James M. Iwanicki, P.E.  
Engineer-Manager

September 14, 2012

Re: Revised Plans and Response to DEQ letter of September 4, 2012  
MDEQ File No. 11-52-0075-P; Proposed CR 595

**Exhibit 3-55. Speed-Distance Curves for a Typical Heavy Truck of 120 kg/kW [200 lb/hp] for Deceleration on Upgrades**

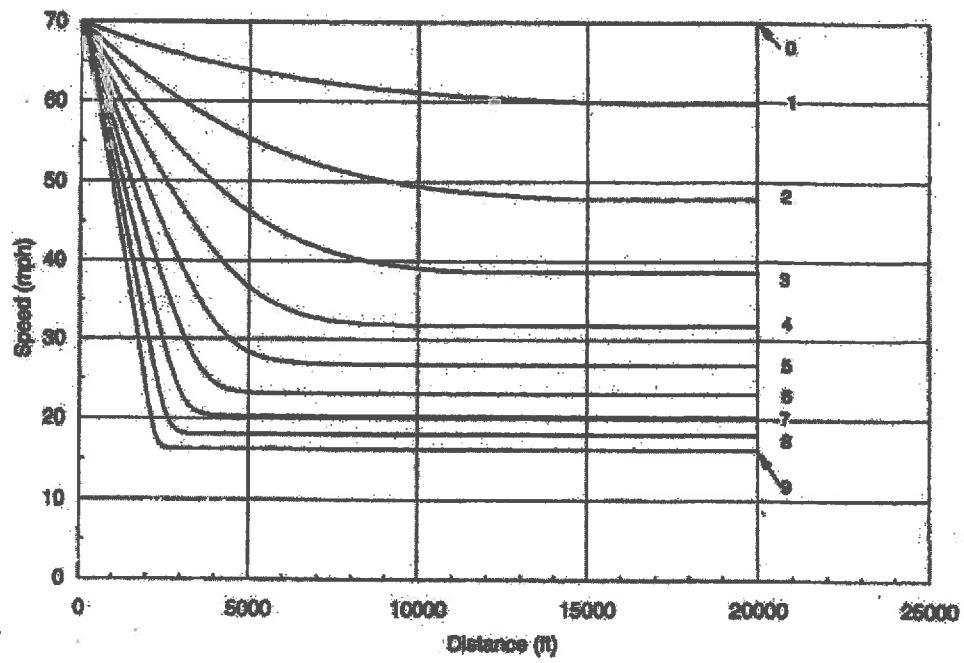
Exhibit 3-55 from the AASHTO Greenbook displayed below illustrates the anticipated deceleration of a typical heavy truck on varying percentages of incline as indicated on the right side of the graph (0%-9%). In addition, Exhibit 3-57 displayed further below illustrates the anticipated deceleration of a typical recreational vehicle on varying degrees of incline. In the case of either trucks or recreational vehicles traversing the rolling terrain encountered along the proposed CR 595, those vehicles will unavoidably experience substantial deceleration on up-hill grades.

**Exhibit 3-58. Crash Involvement Rate of Trucks for Which Running Speeds Are Reduced below Average Running Speed of All Traffic (41)**

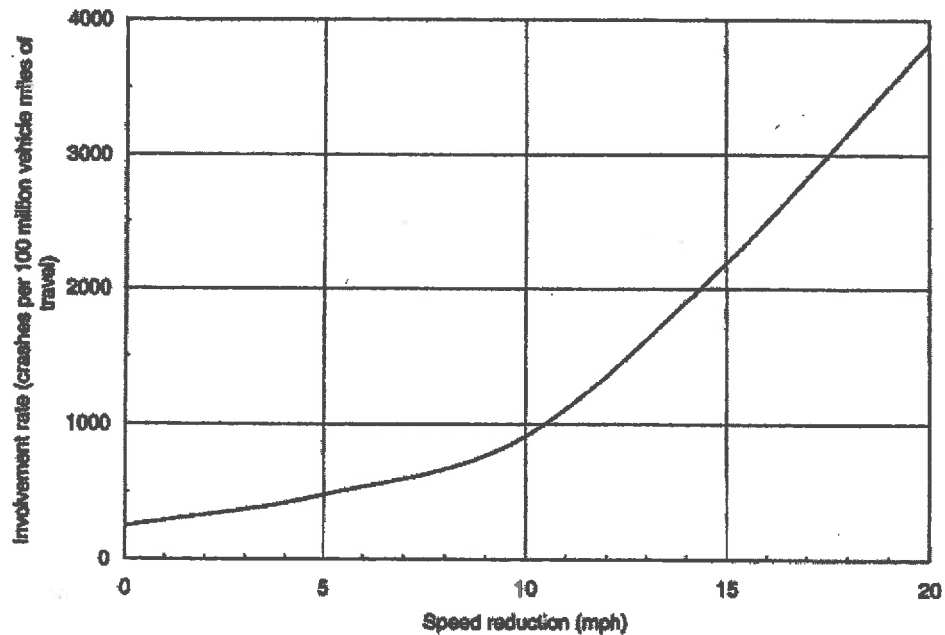
As discussed previously, deviation from average speed increases the chance a vehicle is involved in a crash. Exhibit 3-58 displayed below illustrates the exponential increase in crash involvement rates associated with speed reduction on critical grades.
